Access Compliance Report

Public Rights-of-Way

Intersection ID: 42932	Main Street: CARNSORE_CT	Cross Street: HOLLY_PARK_DR	Location: W
ADA ID: BE279A3AF526	Ramp Type: PerpDiag	Initial Pass/Fail: Fail	Overall Compliance: No
Severity Score: 13.75			
Codes/Mitigation Info/Possible Solution		Field Measurements/Component Compliance

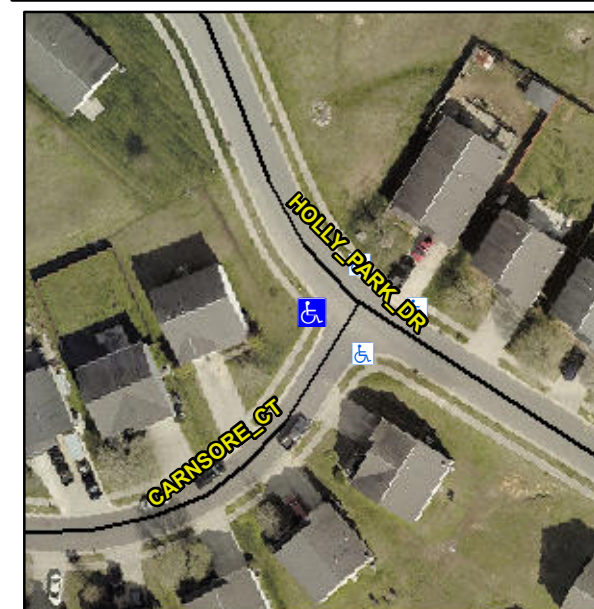
Not Found, R304.2.2, R304.5.3

Compliance	Description	Data	Compliance	Description	Data
N/A	Ramp Length (in)	46.0	No	Ramp Slope (%)	8.4
Yes	Ramp Width (in)	48.0	No	Ramp XSlope (%)	2.4
N/A	Flare Type LT	N/A	N/A	Flare Type RT	N/A
N/A	Flare Slope LT (%)	N/A	N/A	Flare Slope RT (%)	N/A
N/A	Flare Traversable LT?	N/A	N/A	Flare Traversable RT?	N/A
N/A	Landing Length (in)	N/A	N/A	DWS Provided?	N/A
N/A	Landing Width (in)	N/A	N/A	DWS Contrast?	N/A
N/A	Landing Slope (%)	N/A	N/A	DWS Length (in)	N/A
N/A	Landing X Slope (%)	N/A	N/A	DWS Full Width?	N/A
N/A	Landing Curb? (Y/N)	N/A	N/A	DWS Offset (in)	N/A
N/A	Shared Landing?	N/A			
N/A	Gutter Ponding?	N/A	N/A	Gutter Slope (%)	N/A
N/A	Gutter Lip Ht (in)	N/A	N/A	Gutter X Slope (%)	N/A
N/A	Painted X Walk1?	No	N/A	Painted X Walk2?	No
	X Walk 1 Direction	To SE		X Walk 2 Direction	To NE
N/A	X Walk 1 Width (in)	N/A	N/A	X Walk 2 Width (in)	N/A
	X Walk 1 Slope (%)	4.6		X Walk 2 Slope (%)	5.9
	X Walk 1 X Slope (%)	2.7		X Walk 2 X Slope (%)	5.4

Remove & Replace Curb Ramp With Two New Directional Ramps or Equivalent.
